PROJECT: Montecito 1

CITY OF LAS VEGAS		DATE:
INTER-OFFICE MEMORANDUM		July 10, 2019
TO: Land Development Services Department of Building & Safety		FROM: Jennifer Shinn, P.E.  Flood Control, Engr. Associate Department of Public Works
SUBJECT:	Drainage Study for: Montecito Unit 1	COPIES TO: Slater Hanifan Group
Cross Streets:	NEC of Grand Montecito & Deer Springs	KB Home
File Number:	F:\Depot\DSMemos\DS5114B.doc	Bart Anderson, P.E., DevCo
Parcel Number:	125-20-601-003	
Zoning Action:	SDR-74638	
FEMA Flood Zone	YES NO X	
Proposed Storm Drain	YES X NO

**TECHNICAL DRAINAGE STUDY
ADDENDUM
Montecito Unit 1**
City of Las Vegas, Nevada

This letter is submitted in response to the comments contained in the April 23, 2019 review memorandum, regarding the above referenced project. A copy of the City of Las Vegas Public Works (CLVPW) comment letter has been provided in Appendix A.

STORM DRAIN - PLAN VIEW

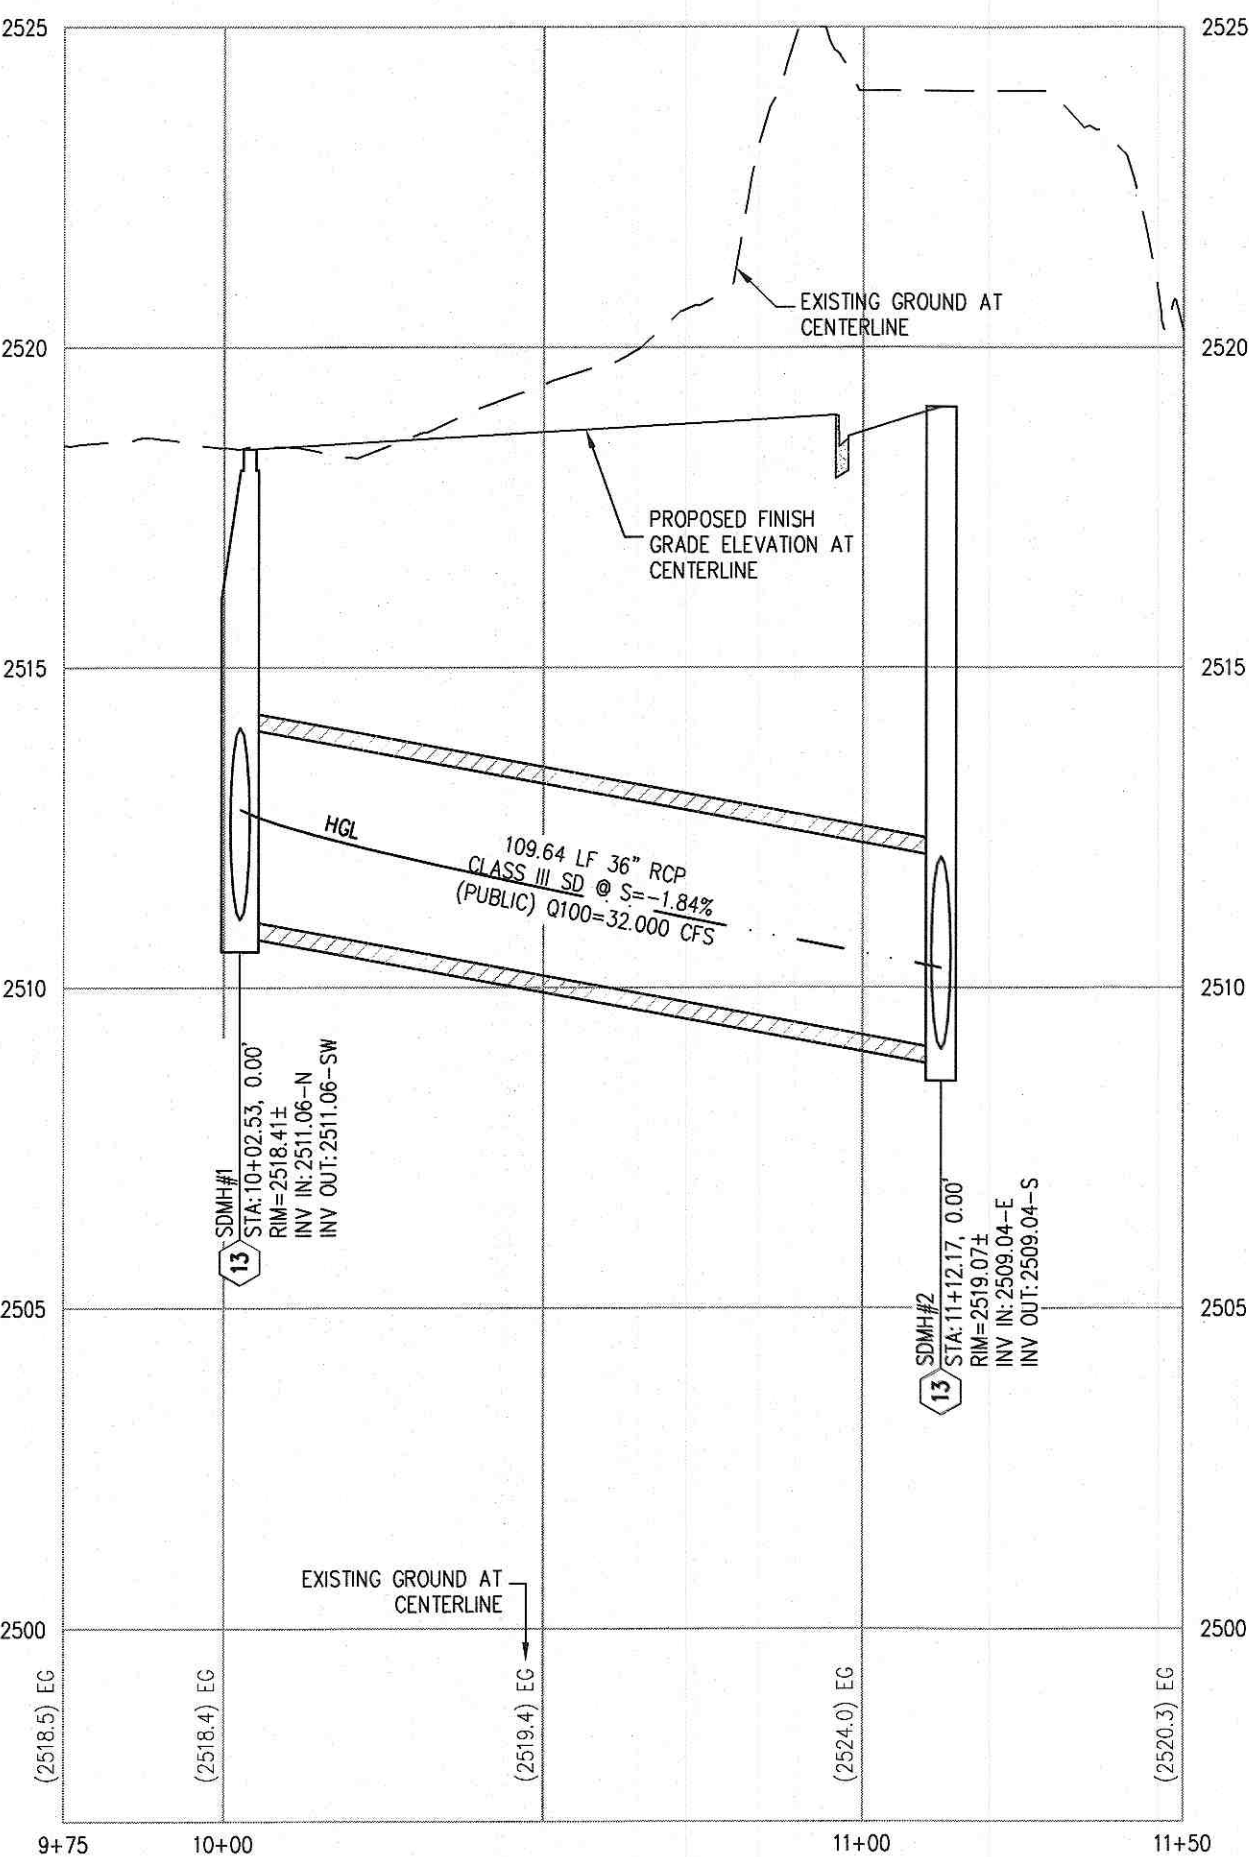
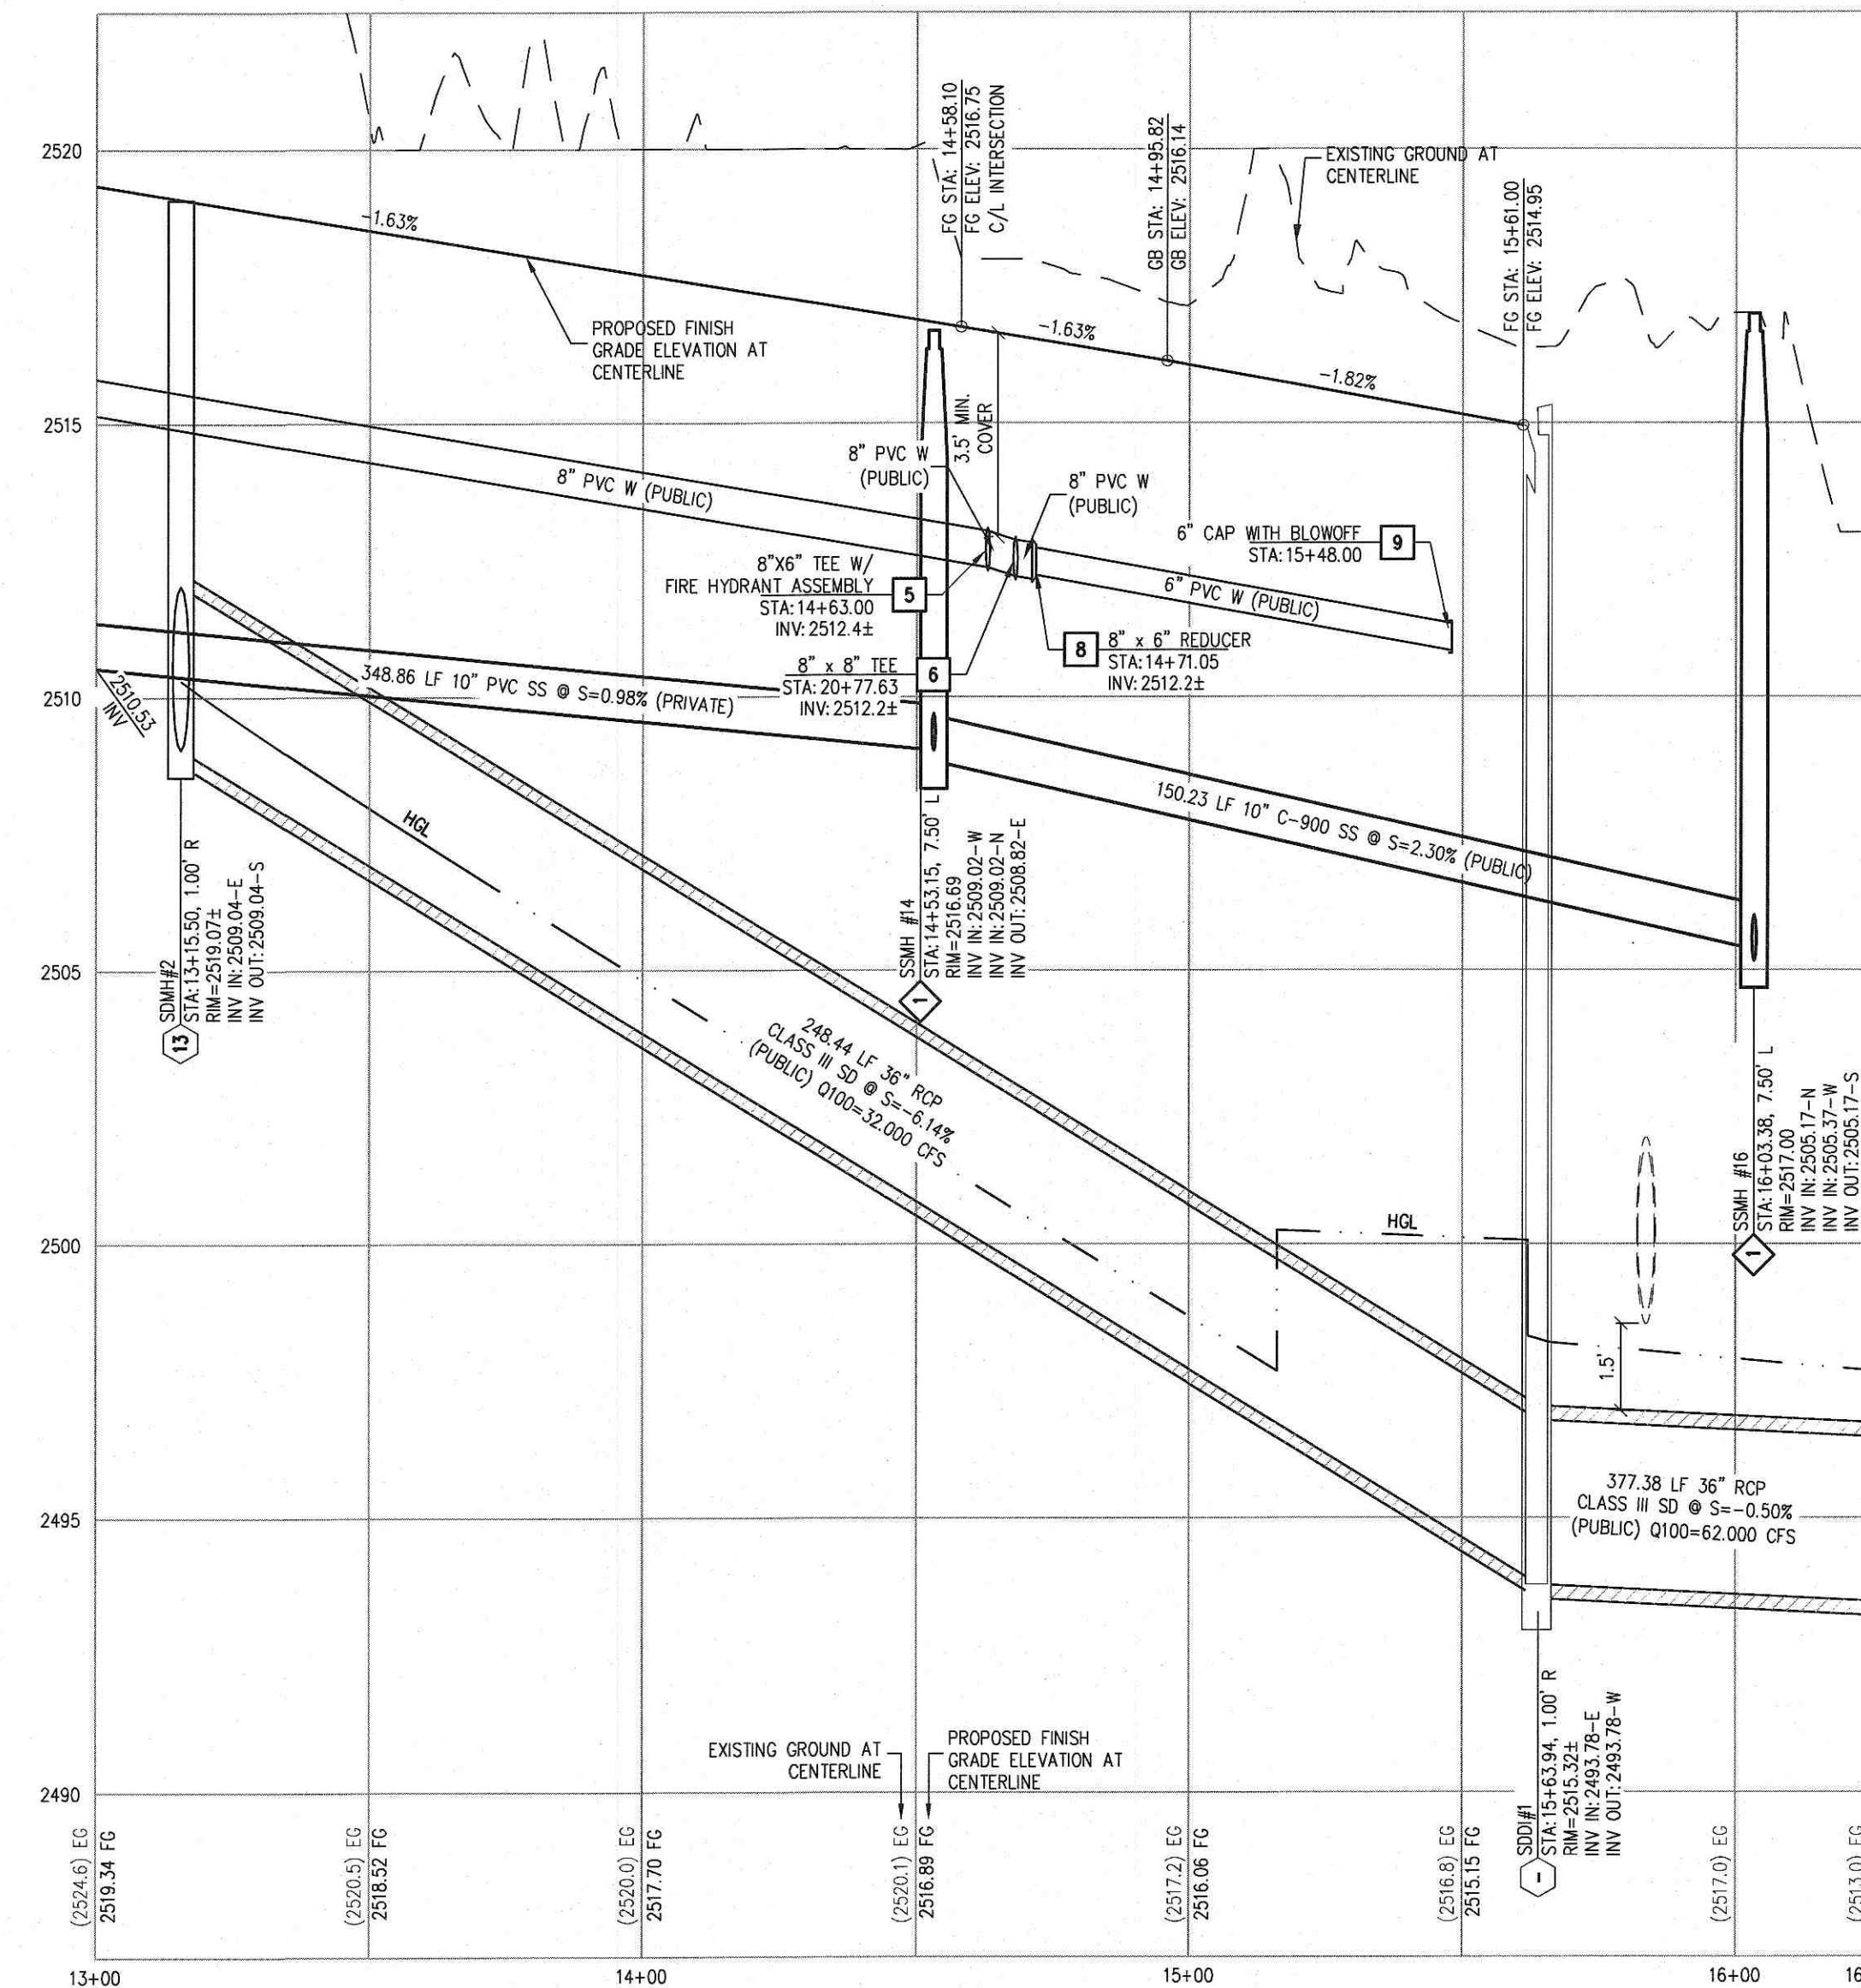
7. **Comment:** *Provide a section detail of the drainage easement required for the storm drain facility within Common Element "P" to demonstrate adequate clearances and minimum easement width is provided by the Manual;*

Response: Acknowledged. Please note that due to conflict with an existing NV Energy conduit along Doe Brook Trail, the storm drain alignment and design has been revised. The storm drain will now align north between Lots 33 and 34 and continue east along Vulturo Avenue until it daylights within the future Unit-2 area. Detail section 14/D-2 has been provided for the drainage easement between Lots 33 and 34 and to demonstrate that the minimum easement width has been provided per the manual criteria. The storm drain hydraulics and outfall computations have been updated and provided in Appendix E.
